## **4.0 FINDINGS AND OBSERVATIONS FROM THE RSE SITE VISIT**

### **4.1 FINDINGS**

FIGURE 4-3. POTENTIOMETRIC SURFACE MAP FOR THE SUGAR ROCK, FEBRUARY 2003

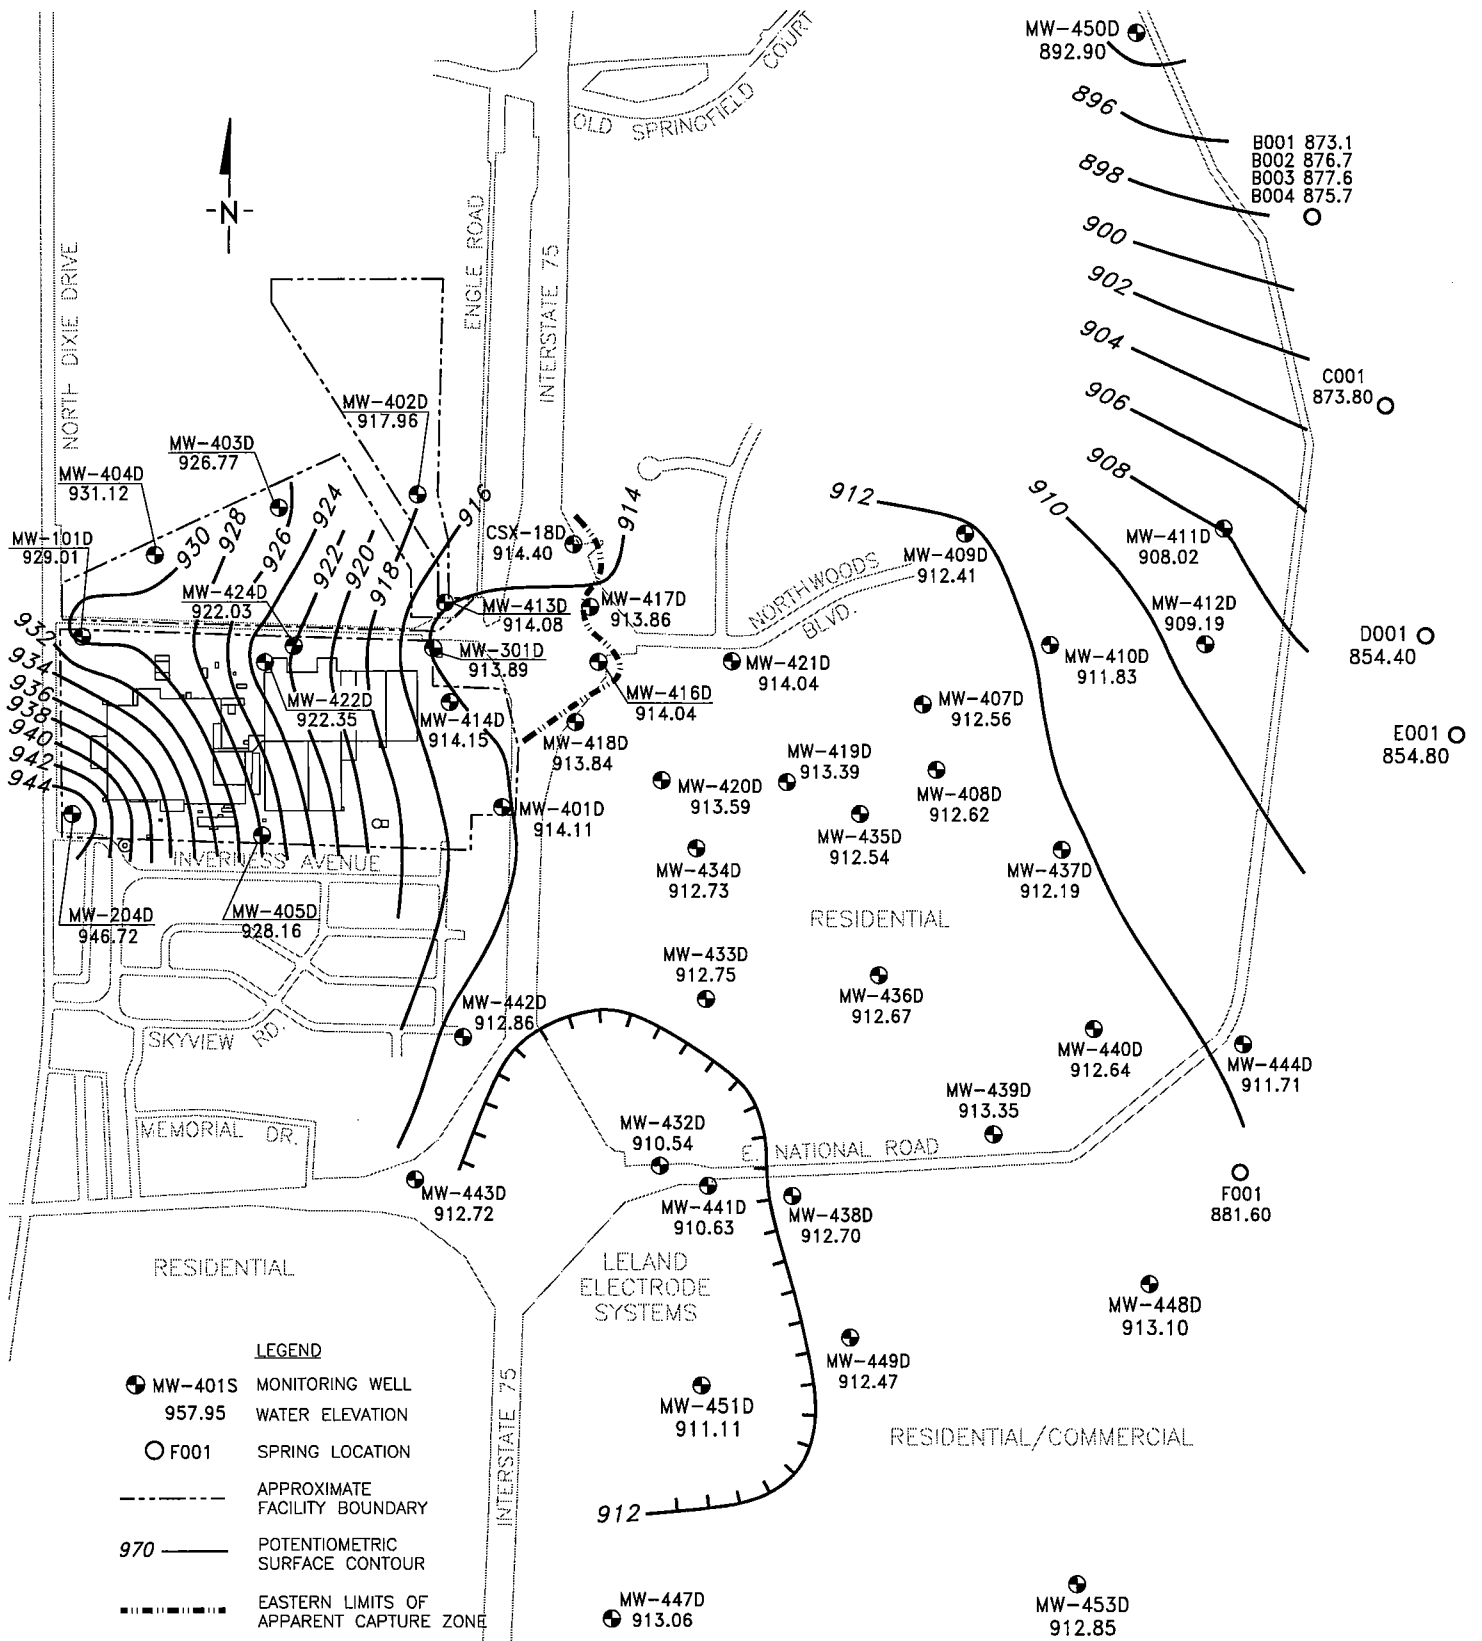
Water levels in the Sugar Rock are collected monthly and corresponding potentiometric surface maps are generated. The results are generally consistent from month to month with some variations due to local pumping. Figures 4-2 and 4-3 depict typical potentiometric surface maps for the Sugar Rock. The primary difference between the two maps is presumably the affect of variable pumping at the Leland/Smith facility. The water elevation across the property typically ranges from 945 feet MSL at the western boundary to approximately 915 feet MSL at the eastern boundary. No mounding is obvious near MW-424D to correspond with the cone of depression near MW-424S in the Top of Rock. Influence from pumping at P-301 at the northeastern corner of the property is evident in both figures. Although the capture zone boundary is not completely outlined, there is sufficient resolution to draw streamlines and outline the estimated horizontal capture zone. The hydraulic gradient to the east of the pumping is relatively flat for approximately 2,000 to 3,000 feet but then steepens again as it turns to the north east. The relatively flat gradient is perhaps in part due to the reduced amount of water flowing through that portion of the aquifer due to pumping from P-301 and from the Leland/Smith well to the south, which pumps an estimated 80 gpm on average. There is a relatively small component of flow from the facility to the southeast in July 2002, but it appears that a more pronounced component is present in February 2003 (Figure 4-3) in which an inward gradient for the Leland/Smith well is apparent.
